# Memo

**To:** The Atherton Planning Commission  
**From:** Sally D Bentz-Dalton, Town Arborist  
**CC:** Sean Manalo, Associate Planner  
**Date:** 9/25/24  
**Re:** Tree Protection Zone (TPZ) Exception 9 Knoll Vista

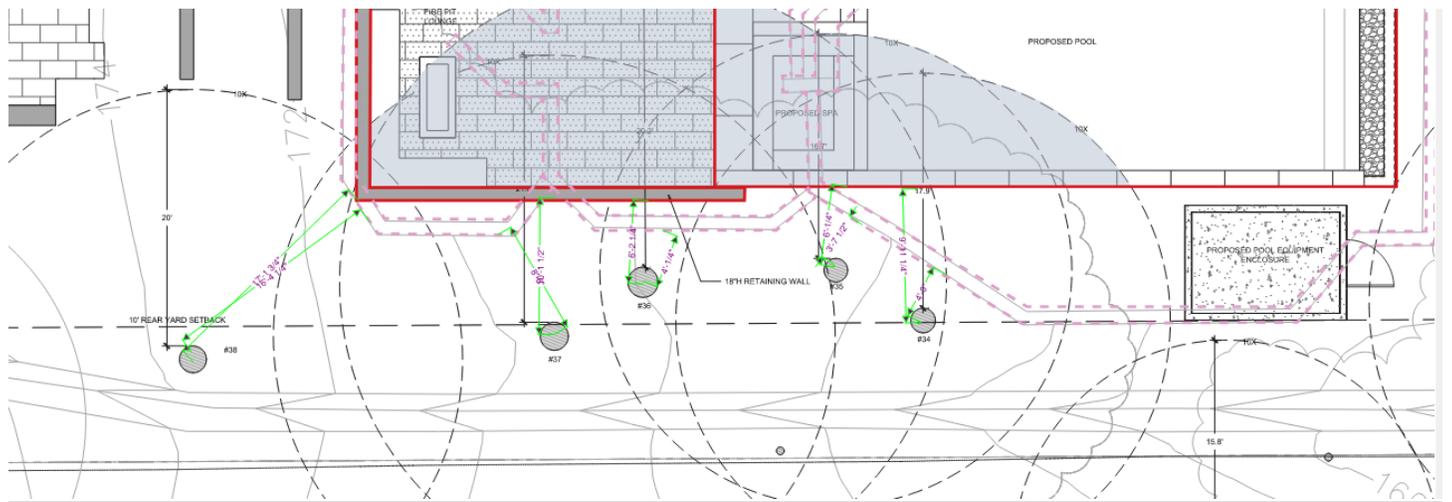
- Tree #37 – 5x - pool, retaining wall and hardscape
- Tree#36 – 3x- pool, retaining wall and hardscape
- Tree #35 – 3x - pool, retaining wall and hardscape
- Tree #34 – 5x – pool, retaining wall and hardscape
- Tree #38 will need a staff level exception of 8x.

For a new pool the TPZ regulation is 10x TPZ. I can grant a staff exception down to 8x. The applicant is asking for 5x and 3x. The current location of the retaining wall and pool do not confirm to our current TPZ regulations. 3x is the start of the critical root area.

The applicant is extending the TPZ for every tree by a few feet. This will improve the area around the trees. However, my concern is the demo work for the existing retaining wall, walls and pool. Kielty states that the plan will benefit the trees as soil space will be increased. The existing retaining walls and pool have likely acted as a root barrier for these trees, and little to no root growth is expected beyond the existing retaining walls. Kielty feels the impacts are expected to be minor to nonexistent as little to no root growth is expected beyond the existing retaining walls where the work is proposed. Impacts from the work are expected to be minor to non-existent.

**I can recommend the below 4 requests with the below requirements:**

Tree #37 – 5x - pool, retaining wall and hardscape

Tree#36 – 3x - pool, retaining wall and hardscape

Tree #35 – 3x - pool, retaining wall and hardscape

Tree #34 – 5x - pool, retaining wall and hardscape

- Demolition of the existing retaining walls within 10x the diameter of the trees will need to be carefully done under the direct supervision of the project arborist. Add note to plans.
- Any exposed roots at the retaining wall will need to be covered by layers of wetted-down burlap to help avoid root desiccation.
- Demolition equipment must be placed as far from the trees as possible during the demolition work to reduce the risk of compaction within the tree protection zones. If access is needed within the tree protection zones, the areas shall be protected by a landscape barrier.
- Exposed roots after demolition shall be covered by native or imported soils and heavily irrigated.

- Excavation for the new pool and retaining walls is required to take place by hand under the direct supervision of the project arborist. Add note to plans.

- All roots encountered must be shown to the project arborist and documented in the required monthly inspection letters during construction
- Any root that needs to be cut must be cut cleanly using a hand saw or loppers while under the direct supervision of the project arborist.

- All excavation is to be done by hand under the Project Arborist supervision when within 10x the tree's diameter.
- Sufficient tree protection installed.

- No roots over 2" to be cut.

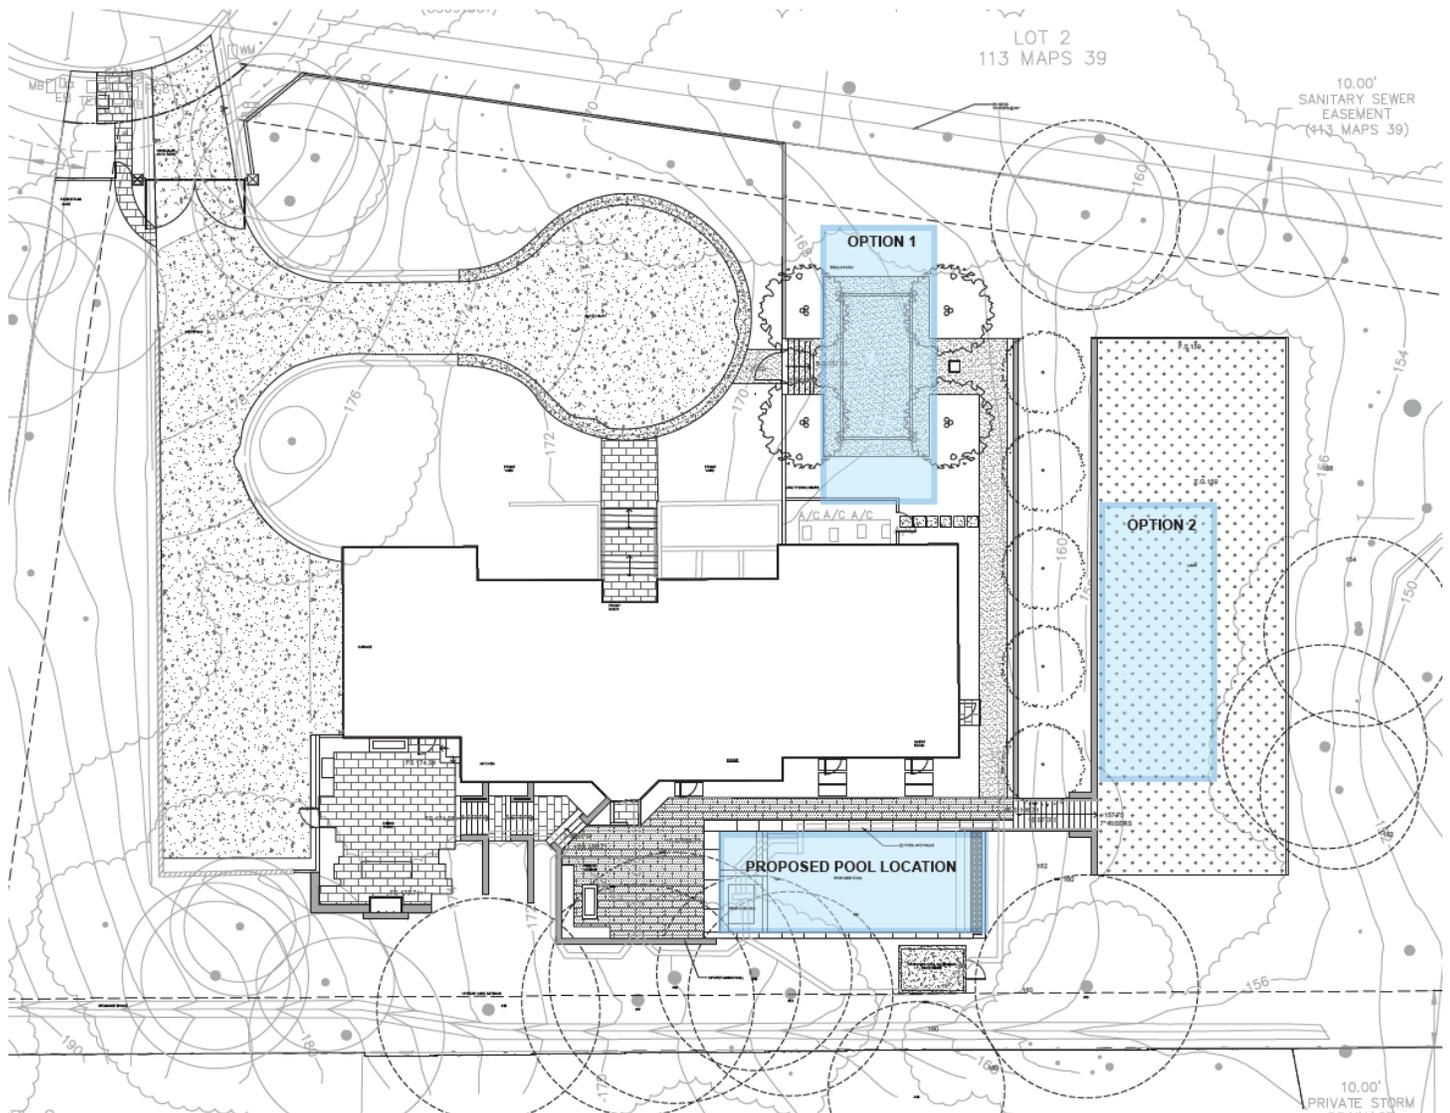
The applicant explored other locations, but they found that none of them were suitable.

**Option 1 - Front Yard:** The front yard space is too tight to host a pool. While we could fit the pool within the setback lines, it would leave minimal space for a pool deck and circulation, making the area impractical for use.

**Option 2: Lower Area (10 feet below house level)** This area is significantly lower than the house's finished floor. Due to the grade change, the clients feel disconnected from the house and the rest of the property when using this location. It would also make it difficult for them to supervise their children while swimming.

**Remaining Areas** The rest of the property is either too steep or allocated for the driveway and circulation, leaving no viable space for the pool.
